MODEL		REV	CHANGE LIST				Model	TW3A M/B	
							Page	From	To
TW3A M/B	3A	First Release 31T3MB0033 (E200601-0720) 2006/1/10					1	3A	
	3B	E200601-5311 2006/2/8					2	3A	
							3	3A	
							4	3A	
							5	3A	
							6	3A	
							7	3A	
							8	3A	
							9	3A	
							10	3A	
							11	3A	
							12	3A	
							13	3A	
							14	3A	3B
							15	3A	
							16	3A	
							17	3A	
							18	3A	
							19	3A	3B
							20	3A	
							21	3A	
							22	3A	
							23	3A	3B
							24	3A	
							25	3A	
							26	3A	3B
							27	3A	3B
							28	3A	
							29	3A	3B
							30	3A	
							31	3A	
							32	3A	3B
							33	3A	3B
							34	3A	
							35	3A	3B
							36	3A	3B
							37	3A	
							38	3A	
							39	3A	
							40	3A	
							41	3A	3B
							42	3A	
							43	3A	3B
							44	3A	
							45	3A	
							46	3A	
							47	3A	
							48	3A	
 PROJECT : TW3A Quanta Computer Inc.		PROJECT: TW3A		ASSY P/N:31TW3MB0033		TITLE:		DOC NO:204	
		APPROVED BY : Johnson Hsu		DRAWING BY : Tony Huang		VER:3B		DATE :02/08/2006

# TW3A- DESIGN

**PROJECT : TW3**  
**Quanta Computer Inc.**

Size	Document Number	Rev
Change Note		3A
Date: Thursday, June 15, 2006	Sheet 45 of 48

88E8038/88E8055

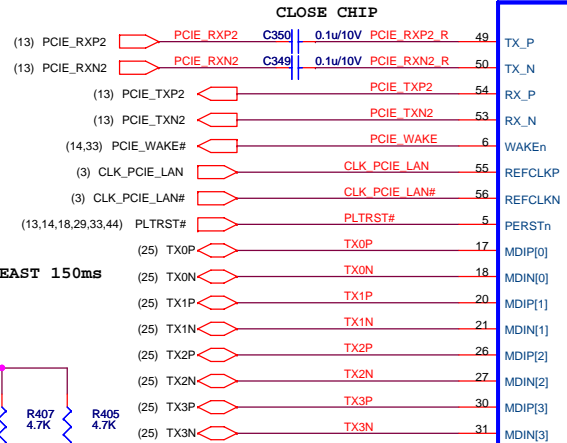
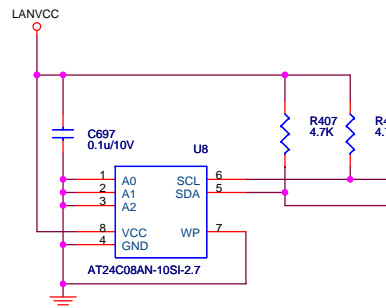
C: Add 9 X GND Pad for LAN controller.  
(20050411)

C: Add these GND pin for via hole to GND Plane.

C: Add RC (R37 change to 200K, Add C101) delay to  
control LOM\_DISABLE#. (20050411)

C: Reserve R36. Change  
LANRST# to PCIRST# source  
from MB option  
modify. (2005/04/11)

<b>PROJECT : TW3</b> <b>Quanta Computer Inc.</b>		
Size	Document Number	Rev
	USB_LED,Bottom/B	3B
Date:	Thursday, June 15, 2006	Sheet 26 of 48

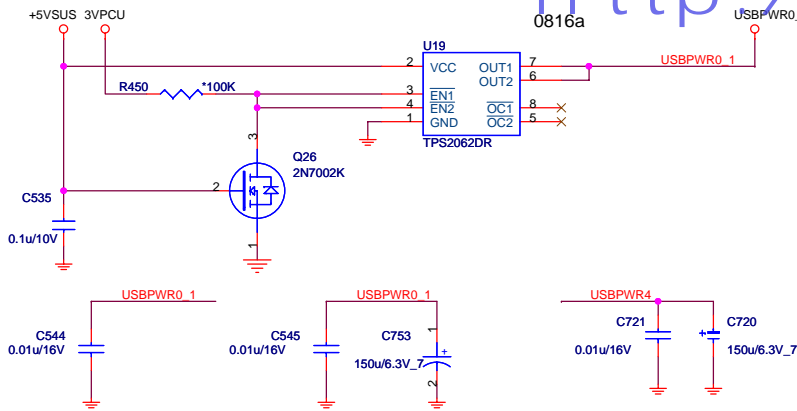
C:Change U1 from G528 to TPS2061

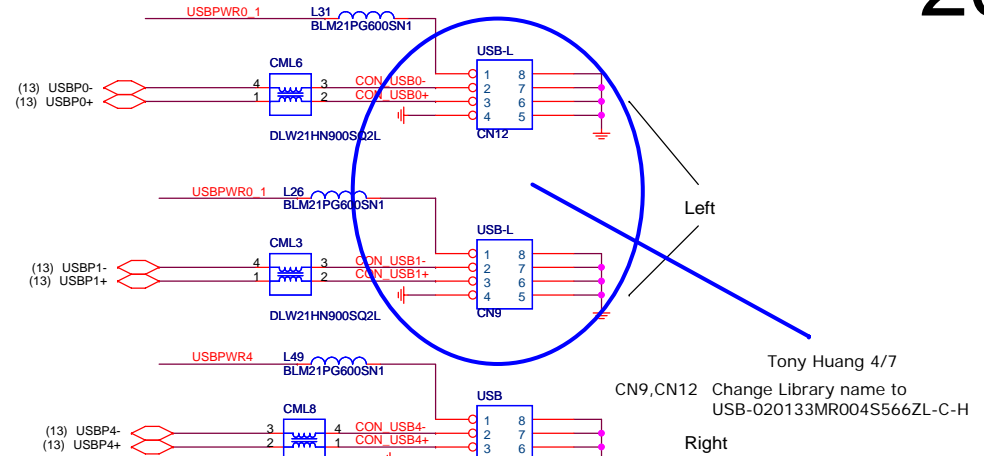
Tony Huang 4/7  
CN9,CN12 Change Library name to  
USB-020133MR004S566ZL-C-H
